**Subsidence
Monitoring
Reports**

From: Chavez, Carl J, EMNRD
Sent: Wednesday, March 1, 2017 9:09 AM
To: 'Parker, Ken'
Cc: Griswold, Jim, EMNRD
Subject: RE: GW-7 Western Jal LPG Storage Facility Subsidence Monitoring Submittal from Pettigrew

RE: Survey Report
Western Refining Subsidence Monitoring

RE: GW-7 Jal LPG Storage Facility
Annual Subsidence Survey Report

PLAT OF SUBSIDENCE MONITORING STATIONS FOR WESTERN REFINING COMPANY
MONITOR STATION LOCATION

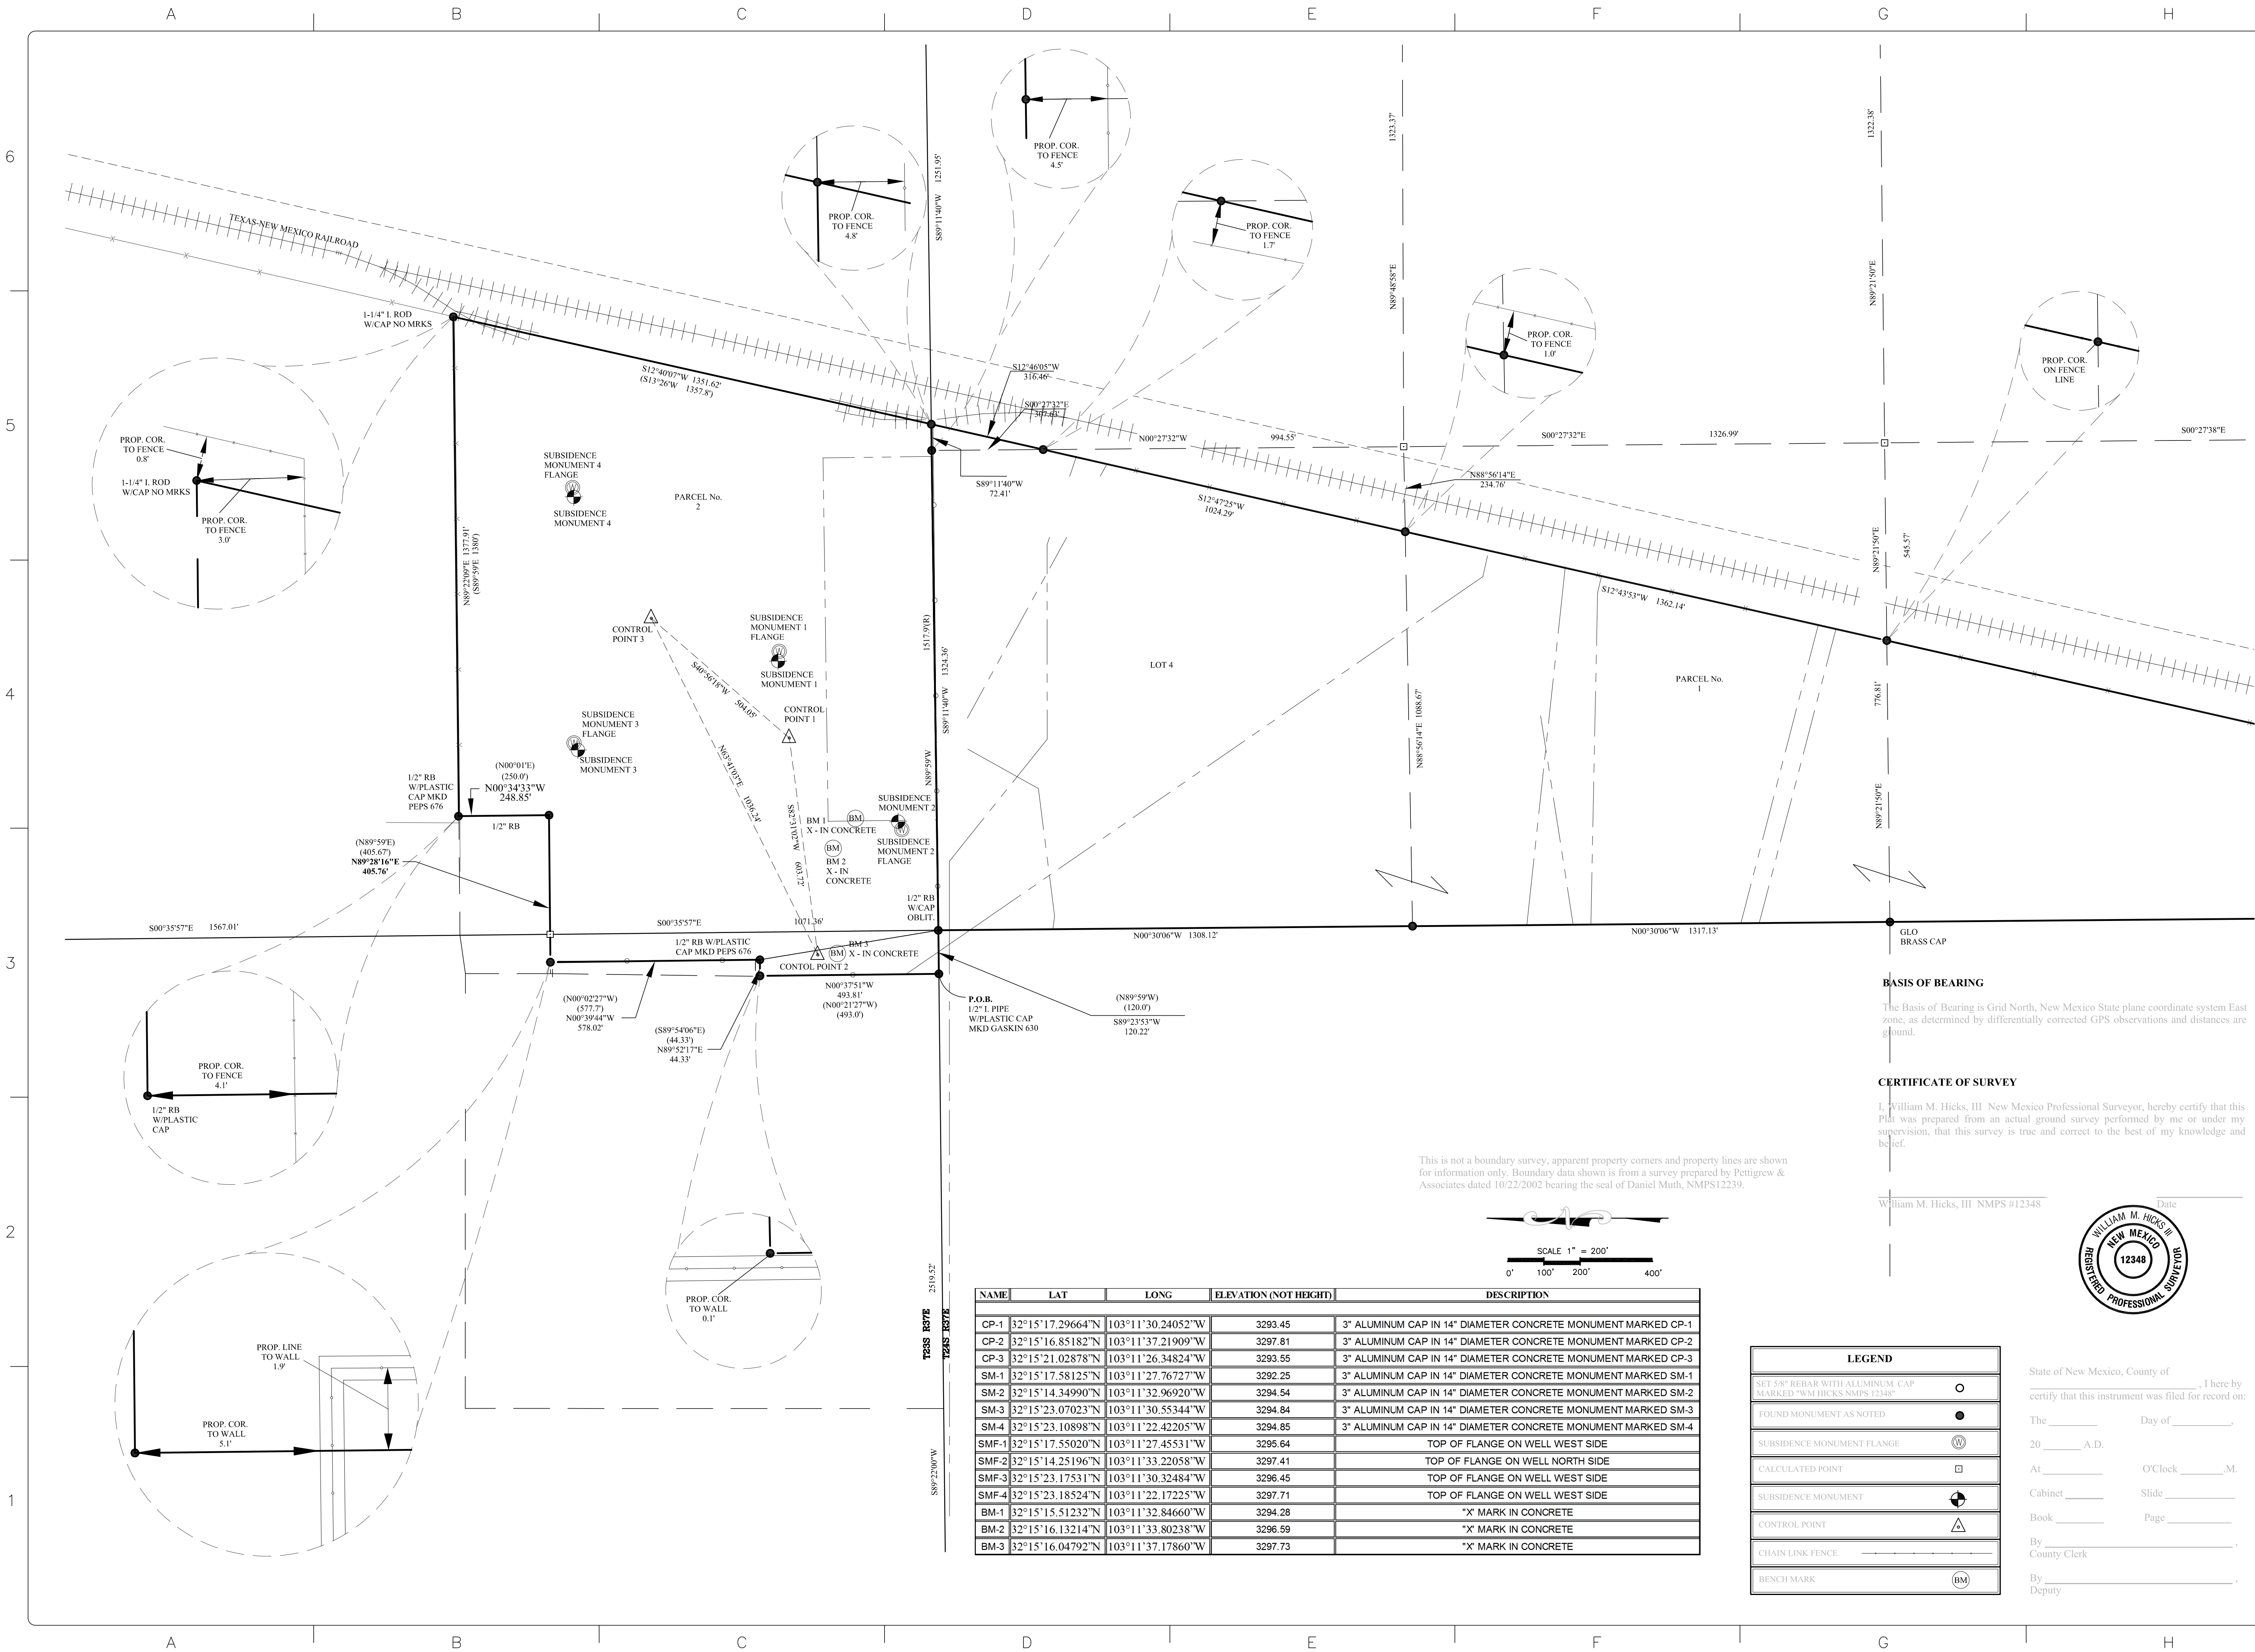
- 1) It is not a report.
- 2) A map with the survey monument locations was not provided.
- 3) The historic numerical mean sea level data of surveyed monument locations was not provided.
- 4) A chart of mean sea-level elevations per monument (feet) to the nearest 1/100th of a foot vs. survey date. A summary of max. deflection per monument location should be stated.
- 5) A summary or evaluation of the observations and results from each monument survey elevational changes is required with conclusions. For example, is there a trend observed at any monument location? Is there isostatic rebound affects observed?
- 6) Provide a description of survey monitoring equipment and accuracy and any changes for future monitoring to improve accuracy of data.
